Building Permit Application

RE: 655 Long Corner Rd.
Mt. Airy, MD 21771
"Before BP Approval"

I have reviewed the building permit application B16003313 and have a couple of comments.

Subject: Project name Long Corner Road
Project site address 655 Long Corner Road
Permit # B16003313 SDP # _____
Other information pertinent to this project _____

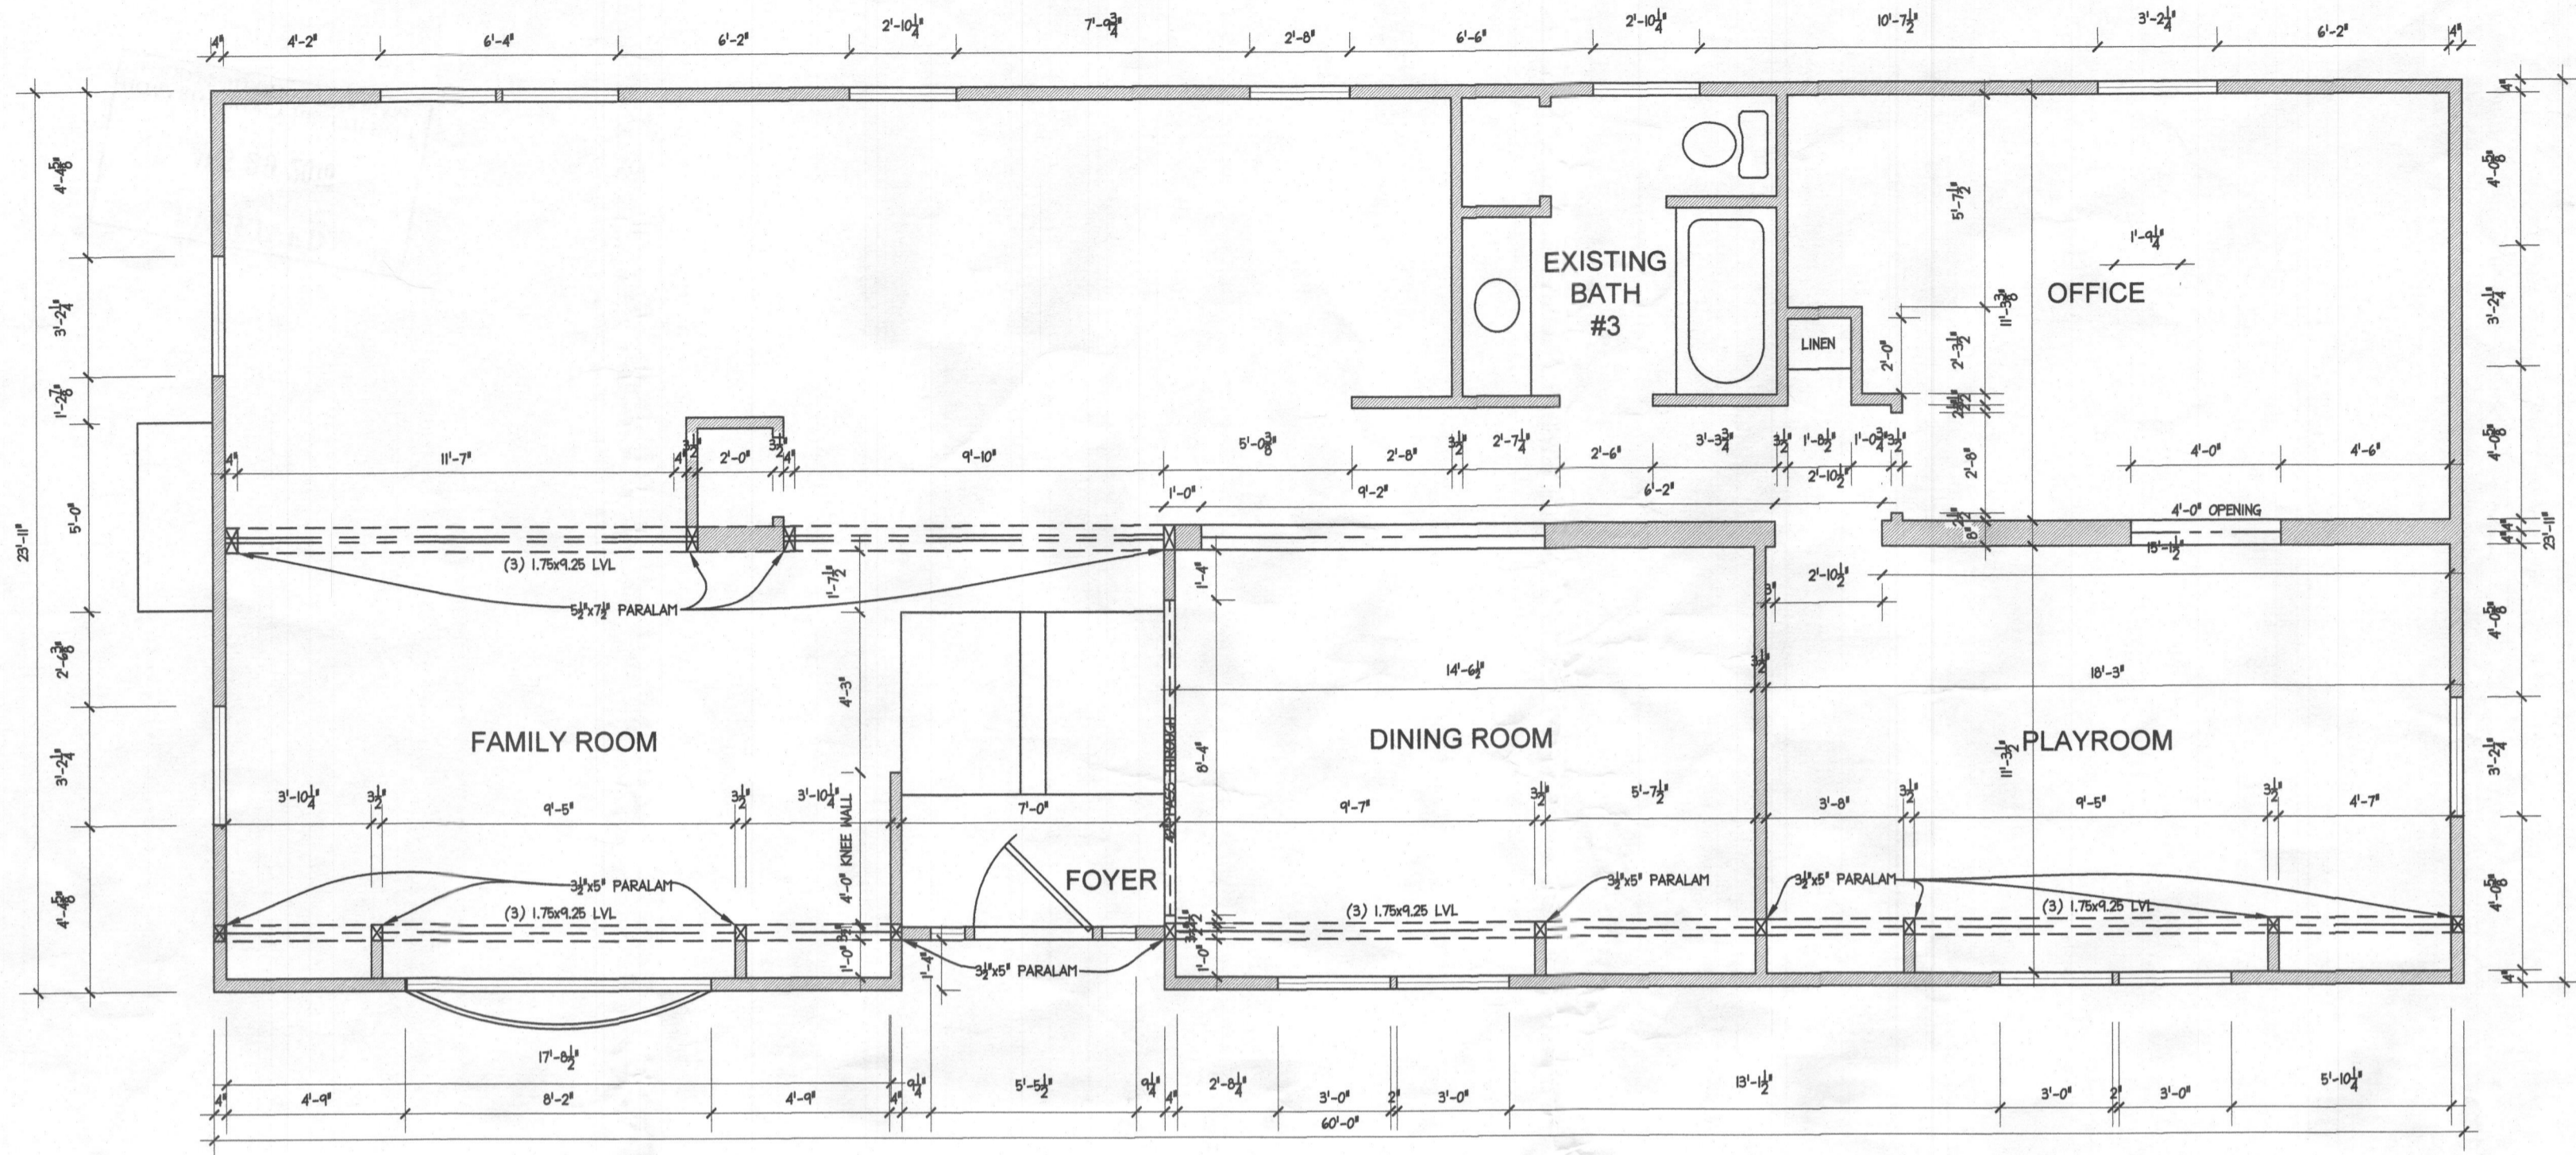
- The current septic system is inadequate for the proposed addition. The septic system is designed to handle a 3 bedroom house. The existing house along with the proposed addition creates a total of 6 bedrooms (1st floor-2BR & 2nd floor-4BR).
- If the decision is to have more than 3 bedrooms a septic system upgrade will be required which will include a Best Available Technology (BAT) Unit. A BAT design plan must be submitted to our office for review and the system must be installed and approved by our Department prior to Health approval of the building permit.
- If the decision is to keep 3 bedrooms the floor plans will need to be adjusted and resubmitted to DILP.

The reason for me writing an email is not that I expect you to fix anything. Although if you are interested I would be happy to discuss my several issues. I was told by Mr. Freemon that two rooms on the first floor are considered "bedrooms" because they have "direct access" to the bathroom on the first floor, even though the access is through a hall and is therefore not direct. I have asked the Washington County Health Department as well as two county building inspectors (Washington and Frederick County) and all of them disagree with your departments definition of "direct access". Would you please send me in writing where your department defines this? Mr. Freemon could not provide this and directed me to contact you via email.

Regarding your question, the onsite sewage disposal section of the county code, section 3.8, does not include a written definition of direct access. We consider direct access to include access through a hallway, similar to how most bedrooms access a bathroom in a typical house floorplan.

FIRST FLOOR PLAN (7'-6" CEILING)
SCALE 1/4" = 1'0"

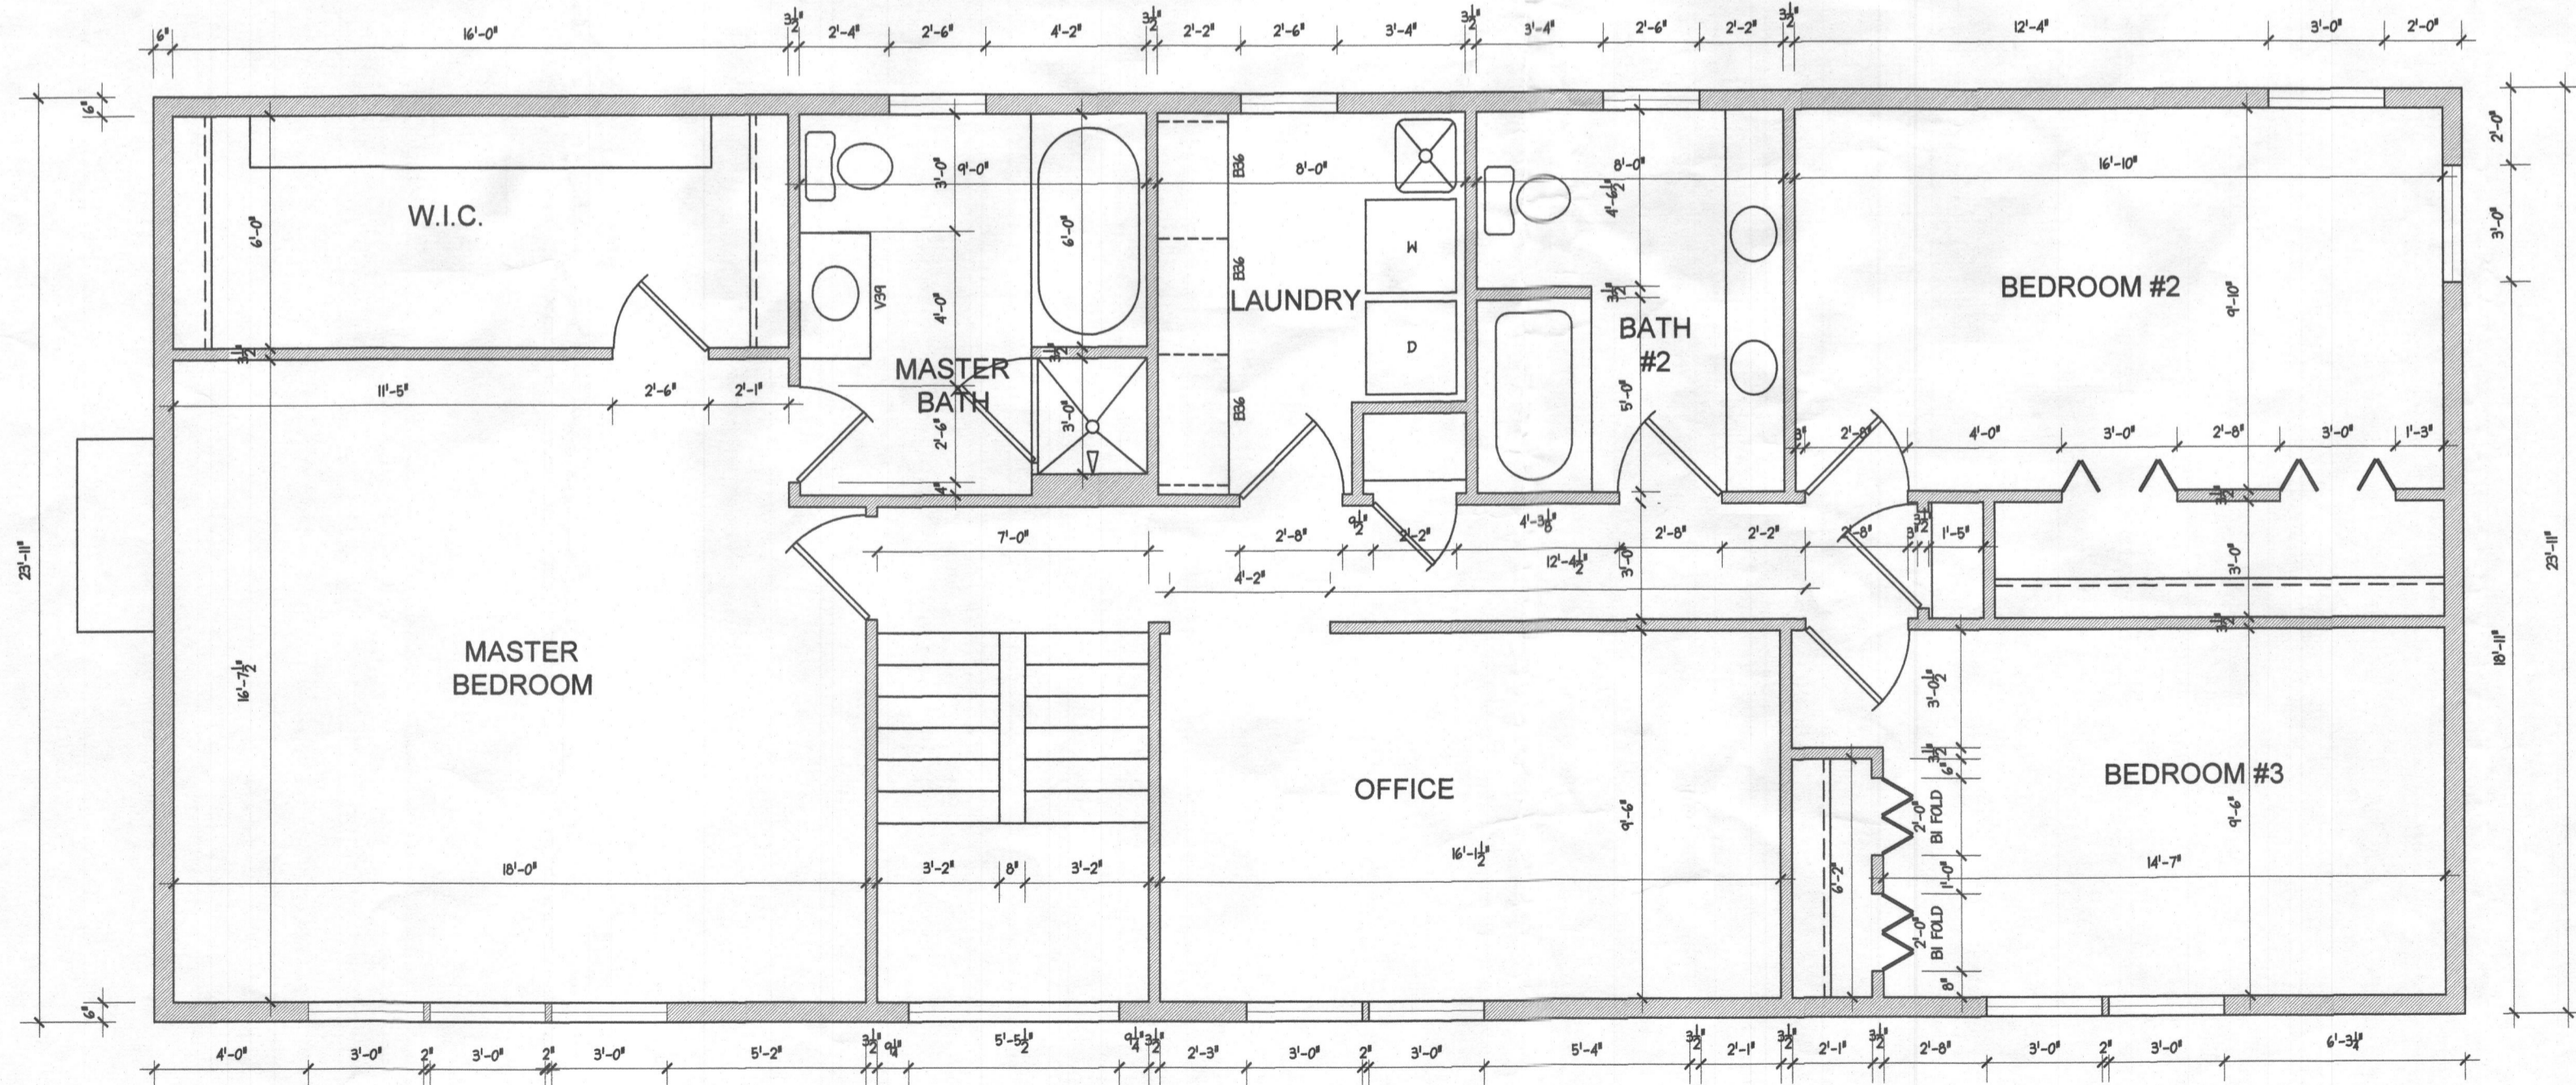
Attached is the new plan. I am going to adjust drawings tomorrow with Permit department.

Approved 8/29/16
[Signature] 51600 3313
B.R.
